Access Compliance Report

Public Rights-of-Way

Intersection ID: 5092	Main Street: BROOKFIELD_POINTE_DR	Cross Street: PENNYCROSS_LN	Location: SE
ADA ID: CA6547E1C274	Ramp Type: Perp	Initial Pass/Fail: Fail	Overall Compliance: No
Severity Score: 13.75			
Codes/Mitigation Info/Possible Solution		Field Measurements/Component Compliance

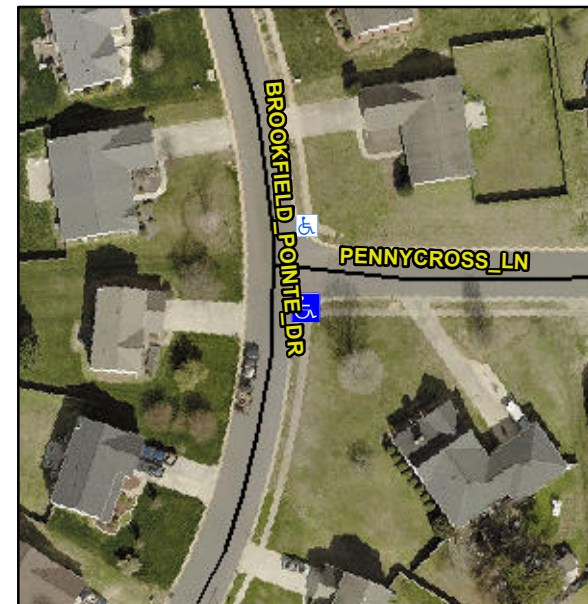
Not Found, R304.2.2, R304.5.3

Compliance	Description	Data	Compliance	Description	Data
N/A	Ramp Length (in)	26.5	No	Ramp Slope (%)	8.4
Yes	Ramp Width (in)	48.0	No	Ramp XSlope (%)	2.8
N/A	Flare Type LT	N/A	N/A	Flare Type RT	N/A
N/A	Flare Slope LT (%)	N/A	N/A	Flare Slope RT (%)	N/A
N/A	Flare Traversable LT?	N/A	N/A	Flare Traversable RT?	N/A
N/A	Landing Length (in)	N/A	N/A	DWS Provided?	N/A
N/A	Landing Width (in)	N/A	N/A	DWS Contrast?	N/A
N/A	Landing Slope (%)	N/A	N/A	DWS Length (in)	N/A
N/A	Landing X Slope (%)	N/A	N/A	DWS Full Width?	N/A
N/A	Landing Curb? (Y/N)	N/A	N/A	DWS Offset (in)	N/A
N/A	Shared Landing?	N/A			
N/A	Gutter Ponding?	N/A	N/A	Gutter Slope (%)	N/A
N/A	Gutter Lip Ht (in)	N/A	N/A	Gutter X Slope (%)	N/A
N/A	Painted X Walk1?	No	N/A	Painted X Walk2?	N/A
	X Walk 1 Direction	To N		X Walk 2 Direction	N/A
N/A	X Walk 1 Width (in)	N/A	N/A	X Walk 2 Width (in)	N/A
	X Walk 1 Slope (%)	1.2		X Walk 2 Slope (%)	N/A
	X Walk 1 X Slope (%)	3.7		X Walk 2 X Slope (%)	N/A

Remove & Replace Entire Ramp.
